## Augmentation capital expenditure review for Energex

**Augmentation Capital Expenditure  
Review**

**Energex 2016 to 2020 Capital  
Expenditure Review**

25 June 2015

Graph 3-1 Power Flow in 11 kV feeder BGY15A

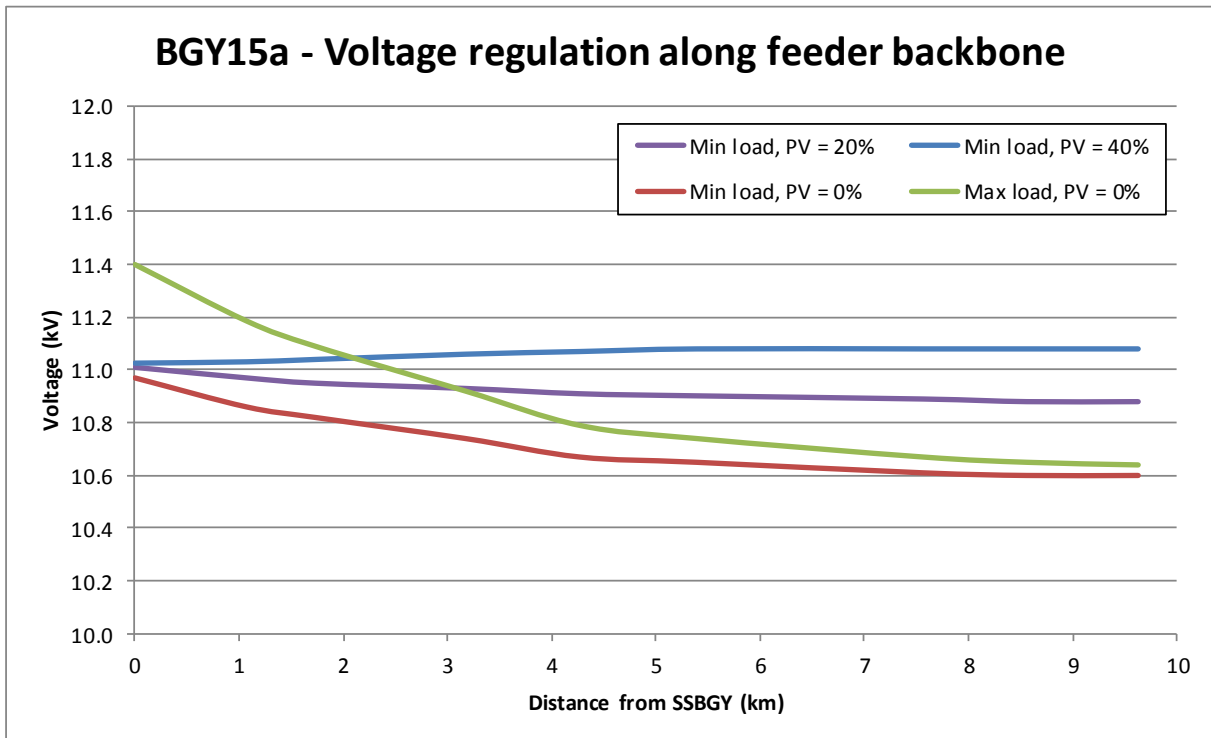
Graph 3.1 above shows the power flow along the feeder. The green trace shows the maximum load case which is the evening peak at around 6 pm. The red trace shows the day time minimum load case during the middle of the day (not the actual minimum which would be around 3 am). The purple trace shows the power flow for an average of 20% solar PV penetration (note, this penetration level has already been exceeded on this feeder). The blue trace shows the power flow for an average 40% penetration along this feeder. The feeder is loaded to approximately 5.2 MVA at peak load. At minimum daytime load with no solar PV, the power flow is approximately 2.4 MVA. With no PV generation, the power flow drops progressively towards the end of the feeder as normally occurs. This feeder shows a heavy concentration of load at between 1km and 2km from the substation, which is likely to be the relatively recent housing estate developments to the west of the Bruce Highway, between Narangba, and Burpengary. These are very obviously more densely developed areas than the surrounds, and this can be clearly seen by viewing the image of the area on a platform like Google Earth. At an average 20% PV penetration (on a high solar day) the power flow beyond this area is entirely supplied by Solar PV during the middle of the day, and between approximately 2 km and 4km from the substation the power flow is close to neutral. At an average 40% solar PV penetration, (on a high solar day), the power flow along the feeder, almost for its entire length flows back to the substation.

Graph 3-2 Voltage Regulation - BGY15A Feeder Backbone

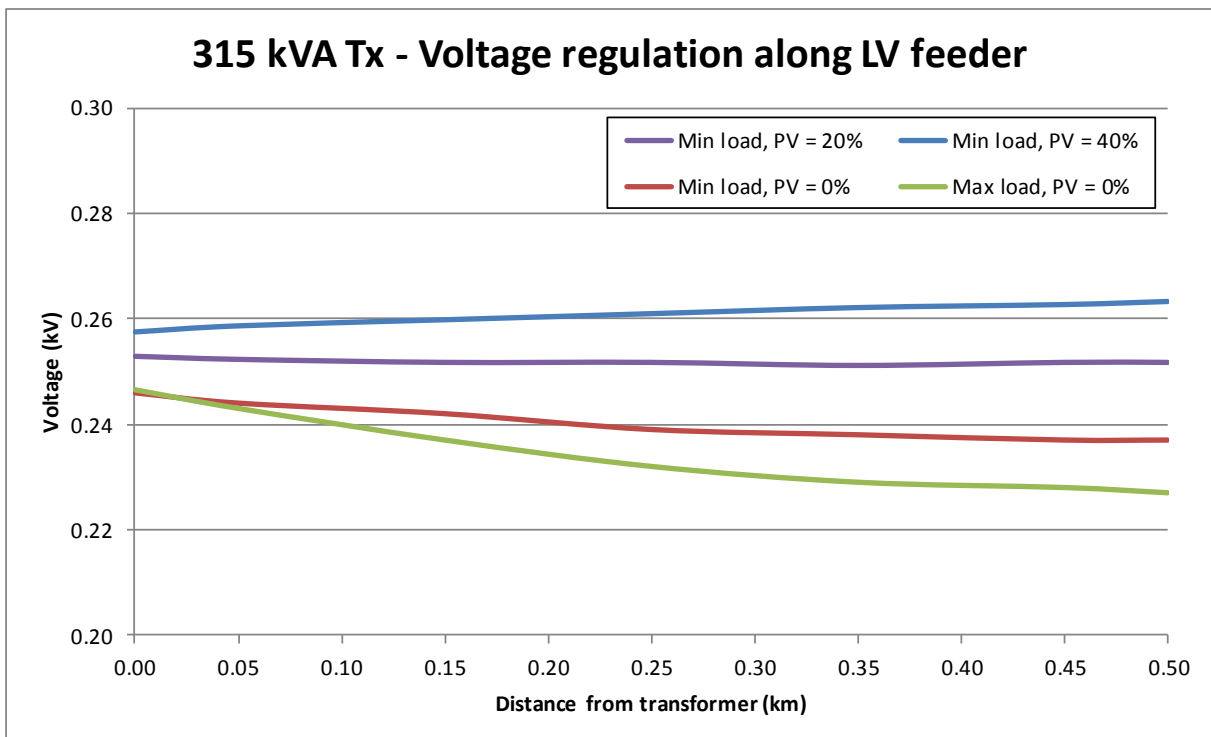
The effect of the solar PV power flow on the 11 kV feeder voltage is shown in graph 3.2 above. This shows the normal situation for minimum and maximum load (the red and green traces respectively), and shows a maximum of 3.9% voltage regulation in the 11 kV network, which happens to be at the start of the feeder. For 20% solar PV penetration, the voltage profile is considerably flattened, but still shows a voltage drop, albeit a moderate one at the end of the feeder of 1.1%. As the solar PV penetration reaches 40% on average, the feeder shows a voltage rise at the end of 0.8%, resulting in total regulation of 4.4%. While this does not seem excessive, it must be remembered that the feeder will now exhibit a 3.9% voltage variation at the front when there is no solar PV influence (at night, and on rainy or cloudy days) and a 4.4% voltage variation at the end, depending on whether there is a solar PV influence or not. It should also be noted that the voltage at the end of the feeder could swing from 11,080 to 10,600 and back in a reasonably short time, as moving cloud cover travels across the area. This will require different distribution transformer tap settings than standard and it may be difficult to accommodate all the variations that will be experienced.
